Addendum #1

23 August 2024

Energy Efficiency Upgrades
Maine Department of Marine Resources Laboratory
194 McKown Point Road
West Boothbay, Maine 04575

Question 19 (Drawing MP101 Keynote 1):

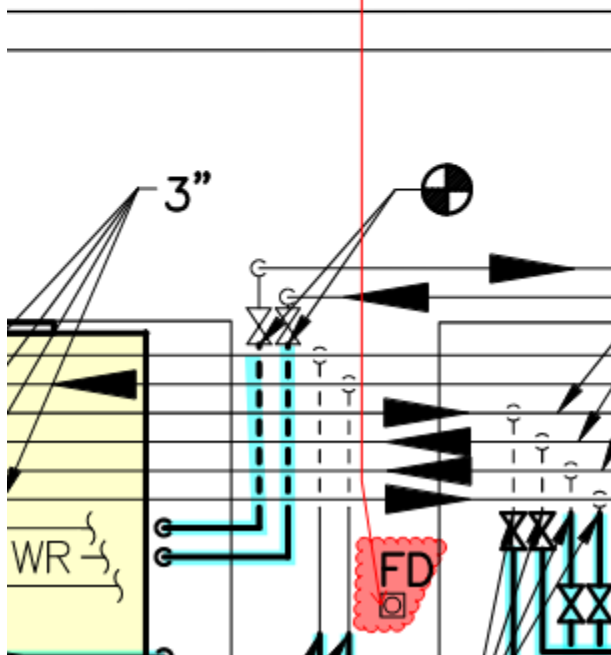
Keynotes: Please confirm where key note # 1 is located on this sheet

This keynote is intended to point to the 3" CWS UP AND DN and 3" CWR UP AND DN located in room 215 HPLC/TRACE CHEM.

Question 21 (Drawing M-401 Detail 3):

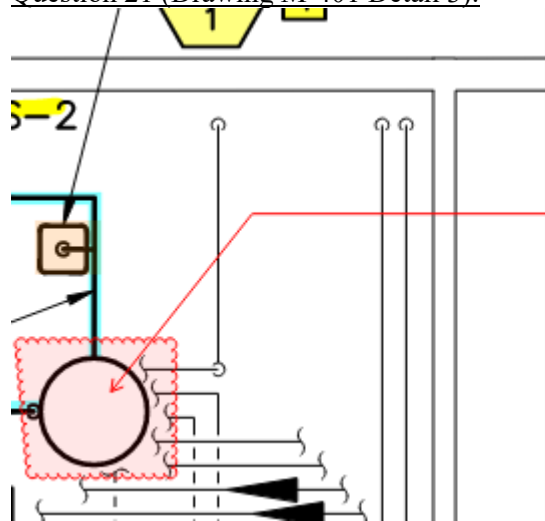
3/M-401: Please confirm what the circle below the GF/1 represents. It has HCS connection Is this new equipment to be furnished and installed?

This is the buffer tank serving HP-1 as described as note 5 on the WATER-TO-WATER HEAT PUMP SCHEDULE.

Question 22 (Drawing M-401 Detail 5):

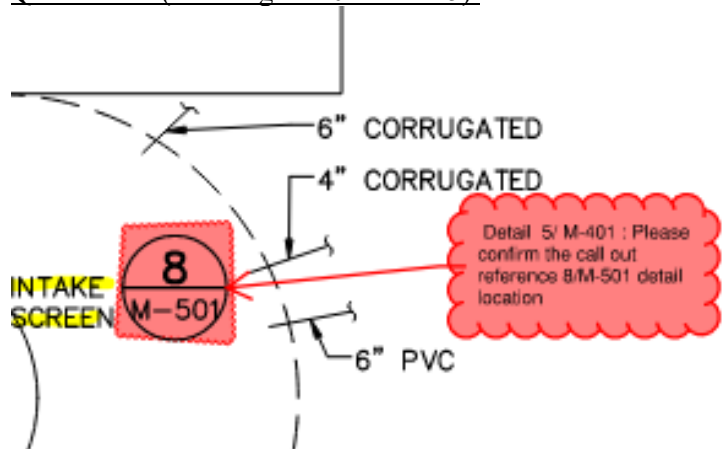
Detail 5/ M-401 : Please confirm the call out reference 8/M-501 detail location

The detail callout on the drawing is correct and references the seawater intake screen.
